UNITED STATES PATENT AND TRADEMARK OFFICE

APPLICATION NO.	FILING DATE	FIRST NAMED INVENTOR	ATTORNEY DOCKET NO.	CONFIRMATION NO.
10/629,774	07/30/2003	Ju Hwan Yun	9988.035.00-US	7781

Office Action Summary

DETAILED ACTION

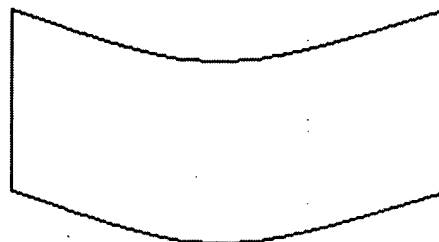
Mills teaches that frame 18 is made of a strip of metal or other flexible, bendable material which is bent into a rectangular form. Although in Mills, the window is illustratively depicted as flat along a front surface, the window may similarly be bent/curved in a left/right direction as anticipated by Mills teaching of a bendable rectangular frame. For example, the frame may obviously be bent for achieving aesthetic purposes such as curvature in the left/right directions, as shown here:

flat front surface

curved front surface

The frame of Mills may be curved, as it is formed of a material which is meant to be flexible and bendable for conforming about the shape of the rectangular window of Mills; although the window of Mills is rectangular, it may embody a flat or curved surface.
